**LAND USE APPLICATION SUMMARY**

*Property Location:* 5605 Nicollet Avenue  
*Project Name:* N/A  
*Prepared By:* Kimberly Holien, Principal City Planner, (612) 673-2402  
*Applicant:* William Wells, Architect  
*Project Contact:* William Wells  
*Request:* To construct a multiple-family residential structure with six dwelling units.  
*Required Applications:*

<b>Variance</b>	To reduce the minimum drive aisle width for three surface parking stalls from 22 feet to 8.5 feet.
<b>Site Plan Review</b>	For a multiple-family residential structure with six dwelling units.

Re: Site plan amendments to a 6 Unit Apartment Building under construction  
at 5605 Nicollet Ave South in Minneapolis.

## Zoning Staff Recommendation

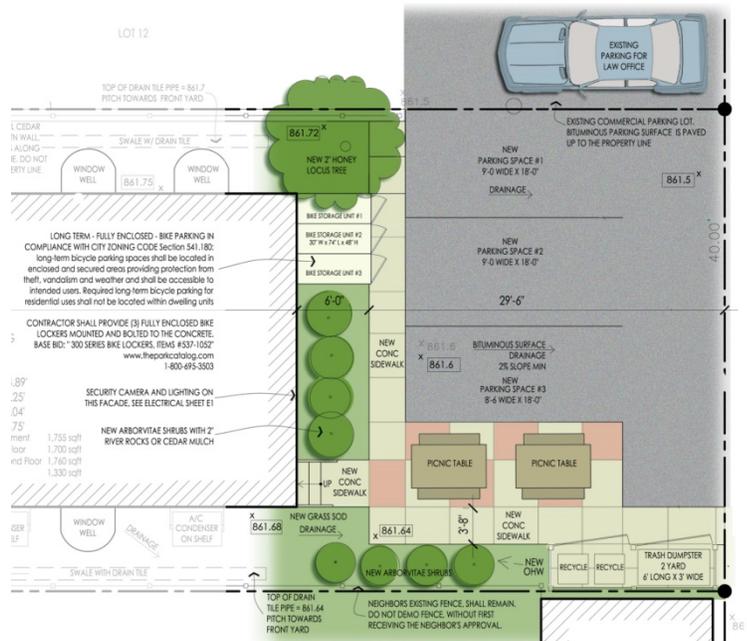
Zoning Staff recommends that a 7' landscape buffer be added on either side on the surface parking lot. The Architect believes the best possible design solution, is to move the parking area as far NORTH as possible, on the site, to mitigate the impact of parking on the existing single family house to the South.

Center the parking and providing a 7'-0" landscape buffer on either side. This has design and maintenance problems. It wastes valuable urban space and does not provide a tenant recreation area.

**SITE PLAN**  
 SCALE: 3/16" = 1'-0"  
 WHEN PRINTED ON 22" X 34" PAPER

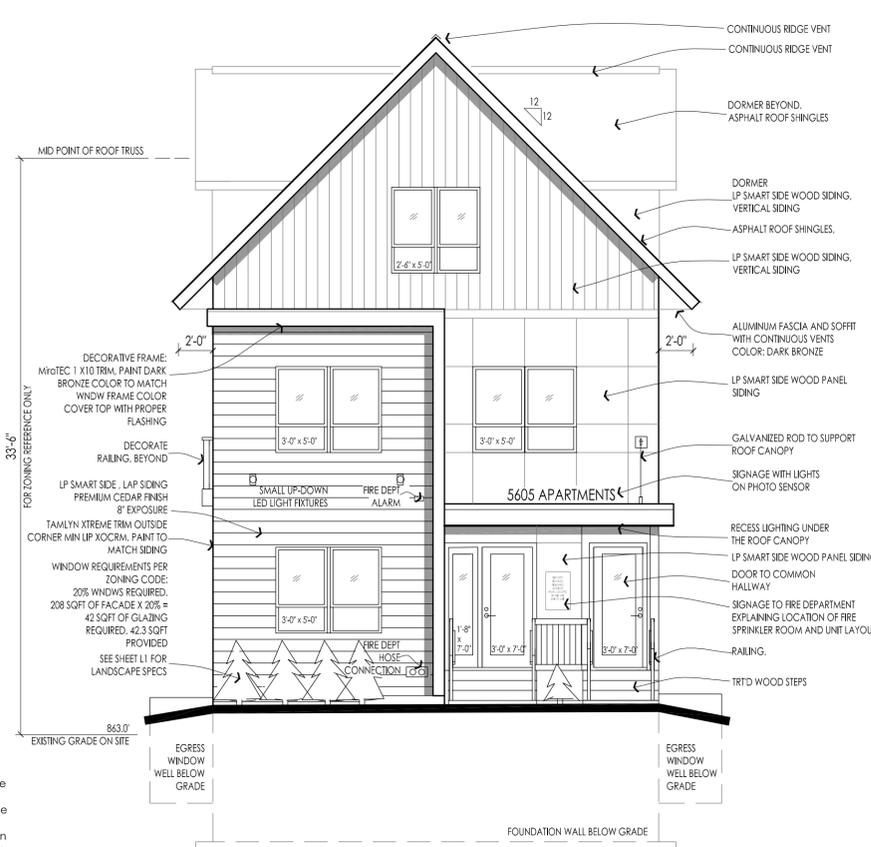
- The parking area that abuts the alley contains requires an on-site landscaped yard of at least seven feet in width between the parking area and the alley and between the parking area and the north and south property lines. The applicant is proposing a ten-foot setback between the south row of parking and the alley.

- The landscaped yards between the parking and the alley and along the north property line require screening that is a minimum of three feet in height and 60 percent opaque. The landscaped yard along the south property line requires screening that is a minimum of six feet in height and 95 percent opaque due to the adjacent residential use.

- Between the parking lot and the alley, no landscaped yard is provided. Similarly, no landscaping is provided between the parking area and the north property line. Alternative compliance is requested.

- Along the south property line, a landscaped yard four feet in width is provided for a portion of the parking lot length and the trash enclosure is proposed on the east end of the parking area. A patio area is also located between the parking area and the south property line. An existing 6-foot tall fence is located between the parking area and the south lot line and the applicant is proposing to provide additional fencing at a height of four feet along the south property line. Alternative compliance is requested for the required screening and the width of the landscaped yard in this location.

1. All site improvements shall be completed by March 16, 2018, unless extended by the Zoning Administrator, or the permit may be revoked for non-compliance.
2. CPED staff shall review and approve the final site, elevation, landscaping, and lighting plans before building permits may be issued.
3. The sign on the west elevation shall not be illuminated, in compliance with Section 543.200 of the zoning code.
4. A landscaped yard four feet in width with screening that is a minimum of three feet in height and 60 percent opaque shall be provided between the parking lot and the north property line, in accordance with Section 530.170 of the zoning code.
5. A landscaped yard a minimum of seven feet in width with screening a minimum of six feet in height and 95 percent opaque shall be provided along the south side of the parking lot, in compliance with Section 530.170 of the zoning code.

**1 FRONT ELEVATION (WEST)**  
SCALE: 3/16" = 1'-0"

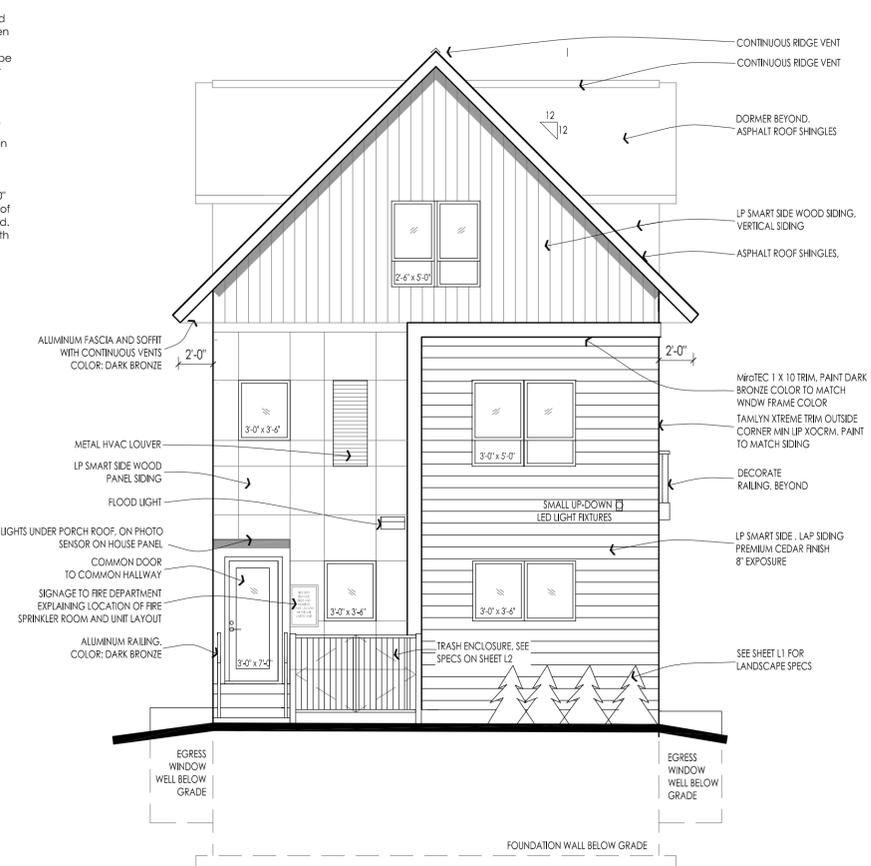
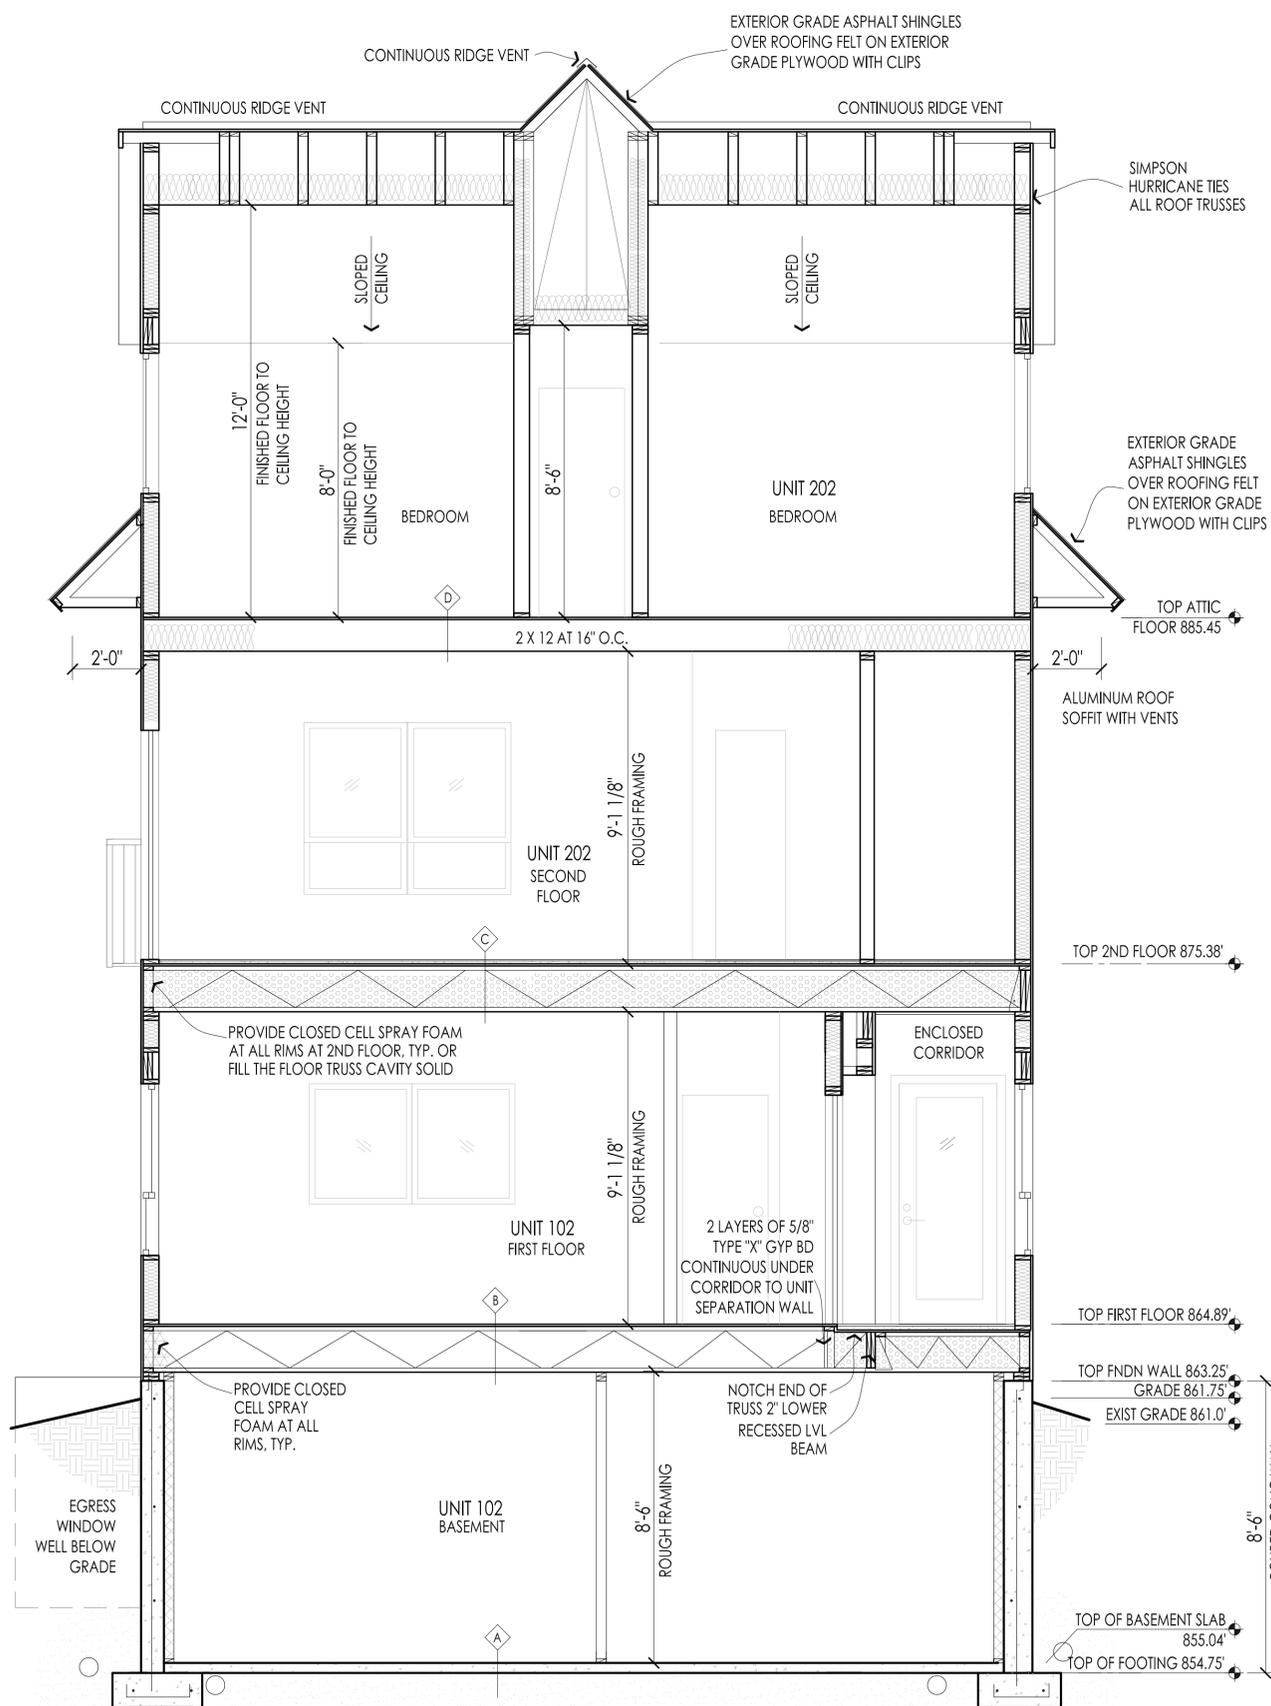
- The applicant is proposing LP Smart Side lap siding and LP Smart Side wood panel siding as the primary exterior materials. This material is akin to wood siding, which is limited to 75 percent of each elevation. Alternative compliance is requested for the City’s durability standards (see Table 1).

- For residential uses, the zoning code requires that no less than 20 percent of the walls on the first floor, and no less than ten percent of the walls on each floor above the first that face a public street, public sidewalk, public pathway, or on-site parking lot, shall be windows. The project is in compliance with the minimum window requirement (see Table 2).
- The only elevation with a minimum window requirement is the west elevation. However, windows are provided on all elevations of the building.
- All windows are vertical in proportion and are evenly distributed along the building walls.
